ASSESSMENT REPORT

Berry and Walker Streets, North Sydney
MP 08_0238 MOD 6

Figure 3: Approved (top) and proposed (bottom) lower ground level layout (Sources: MP 08_0238 MOD 5 and Proponent's application)

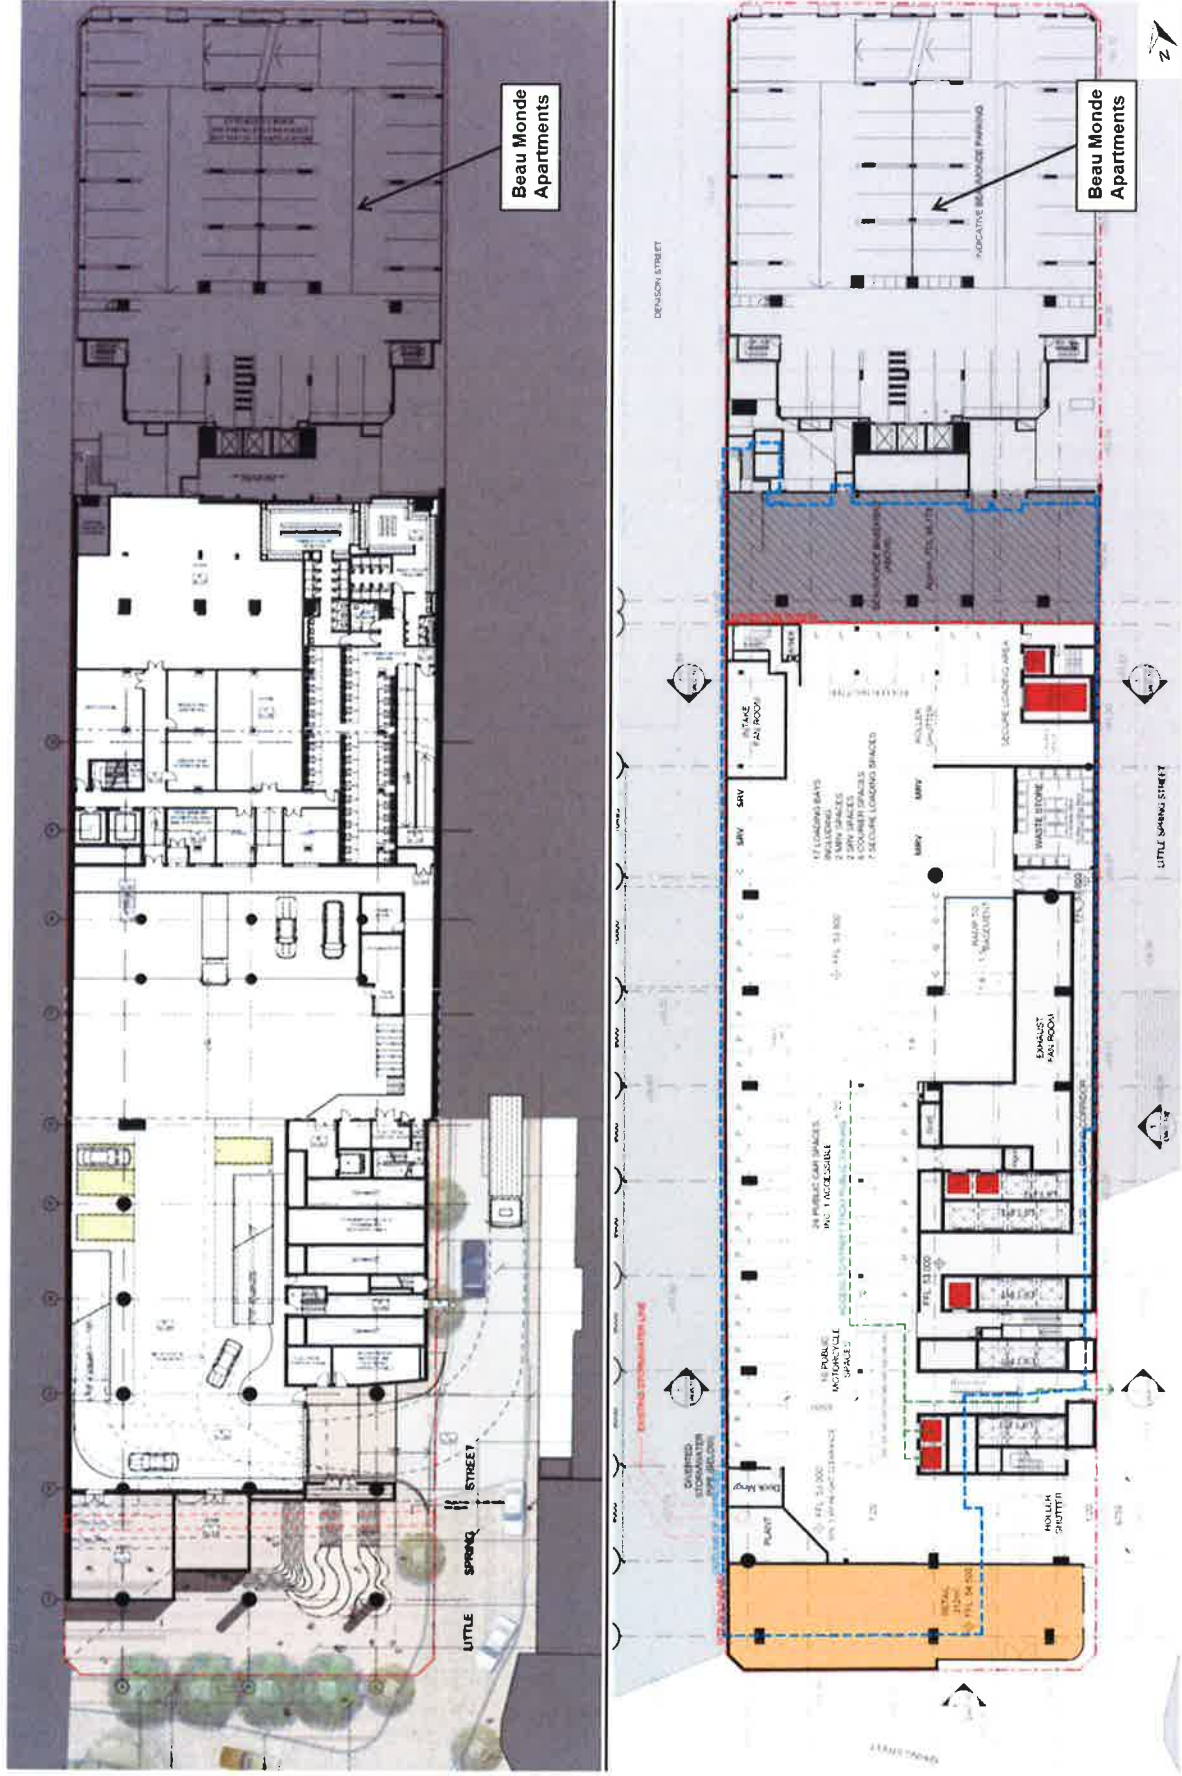
- expansion and redesign of the lower ground and basement levels 1-4;
- changes to public car parking;
- increase of car, motorcycle and bicycle parking spaces;
- replacement and augmentation of the existing stormwater infrastructure; and
- associated amendments to conditions.

The modification is requested in order to provide a more efficient basement layout and to facilitate an enlarged and amended development as envisaged under the concurrent modification request MP 08_0238 MOD 7. The modifications are shown at **Figures 3 and 4**.
